Medworth Energy from Waste Combined Heat and Power Facility

PINS ref. EN010110
Document Reference: 12.2c
Revision 1.0
Deadline 4
May 2023

Written Summary of the Applicant's Oral Submissions at ISH5

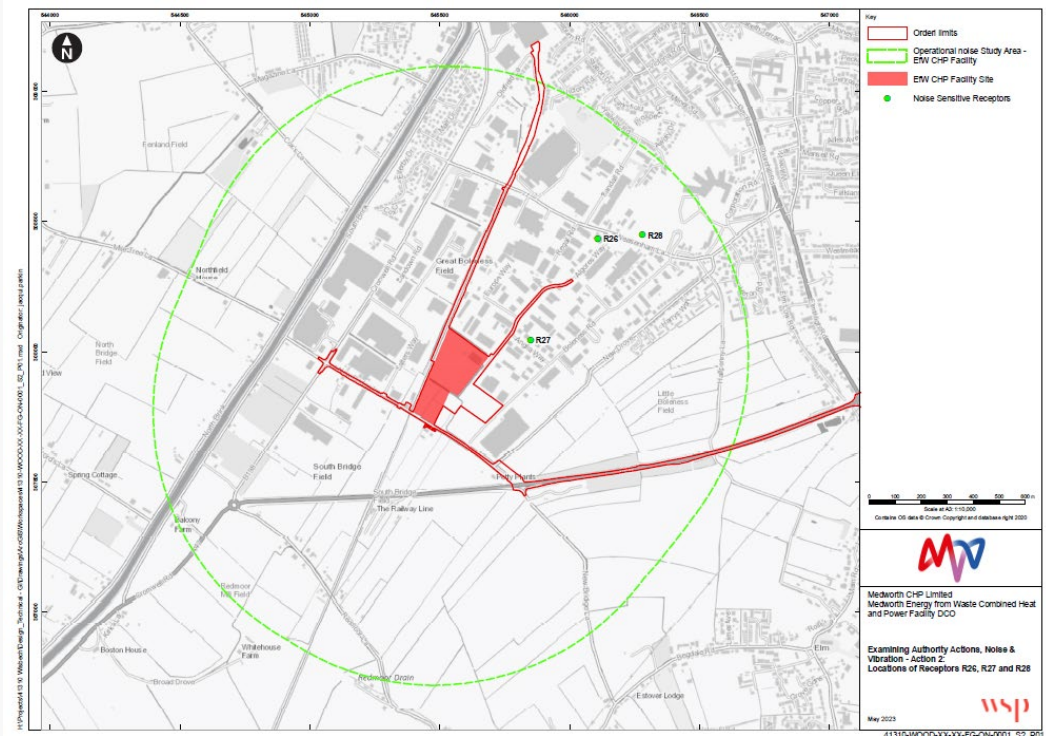
Item	ExA Question/ Context for Discussion	Applicant's Response
		<p><i>out the status of agreement on both the construction and operational noise management plans.]</i></p> <p>In response to the ExA asking why R26 and R28 do not feature in Figure 7.38, Ms Brodrick explained that the standard practice in noise assessments is starting with the receptors closest to the site, and moving away until you find receptors where noise levels were acceptable. Because of this, it was not necessary to consider educational establishments that were further away than other receptors that had been found to have not significant effects. Receptor 27 is the closest education receptor to the Proposed Development and because the effects are considered not significant to this receptor, it is not necessary to consider educational establishments located further away. The Applicant agreed to explain the methodology in Table 7.36, Table 7.37 and Table 7.38 in more detail, including the reasons why certain receptors are listed and others are not, for Deadline 5. <i>[Post Hearing Note: the Applicant's methodology has been explained for Deadline 4, see Table 1.2 ISH5-1 below].</i></p> <p>In response to the ExA's request for the Applicant to talk through the information in Figure 7.3, Mr Hine noted the redline shows the Order limits for the Grid Connection and the 300m study area has been applied to that Order limit. Long term and short-term monitoring locations have been used and, in response to the ExA asking why there was no long term monitoring for the Walsoken Substation, Mr Hine noted that switch gear going into the substation is not considered noise generating equipment and so long term monitoring was not considered necessary.</p> <p>Ms Brodrick noted that notwithstanding the conclusions of the ES, the Applicant had amended the Outline Operational Noise Management Plan [REP3-016] and the draft DCO [REP3-007] to provide for noise management measures to be put in place in relation to the substation. Mr Hine confirmed that the monitoring locations and the nature of short term and long term monitoring has been agreed with both CCC and FDC.</p> <p>In response to the ExA's request of the Applicant to explain Figure 7.39, particularly where construction noise is confirmed to be a significant effect, Mr Hine confirmed that receptors where construction noise was deemed significant were receptors in close proximity to the EfW Facility and that this has been dealt with through the mitigation in</p>

The information in the table above indicates that R26 and R28 are around three to four times further away from the EfW CHP Facility than R27. A figure is provided below which shows that Receptors R26, R27 and R28 all lie a similar direction from the EfW CHP Facility, but that R26 and R28 are at a much greater distance from the EfW CHP Facility than R27 (See figure below).

It is noted that the noise environment at R26 and R28 is dominated by sound from road traffic on Weasenham Lane. Therefore, whilst effects of moderate significance are indicated at R27 (which are not significant), it is considered that likely significant effects

Ref	Party	Action Point	Deadline	Applicant's Response						
				<p>are R26 and R28 would be no greater than moderate and would tend towards negligible significance.</p> <p>Based on the above, it is considered that the assessment of operational noise emissions at R27 will ensure appropriate control of operational noise emissions at R26 and R28 also.</p>						
ISH5-3	Applicant	Applicant to submit information relating to liaison and agreements with Fenland District Council on Noise and provide references to examination library references where information can be found.	Deadline 5	<p>Liaison with Fenland District Council on the approach to the Noise and Vibration assessment are set out in the ES Chapter 7 Noise and Vibration [APP-034], in the following locations within the document:</p>
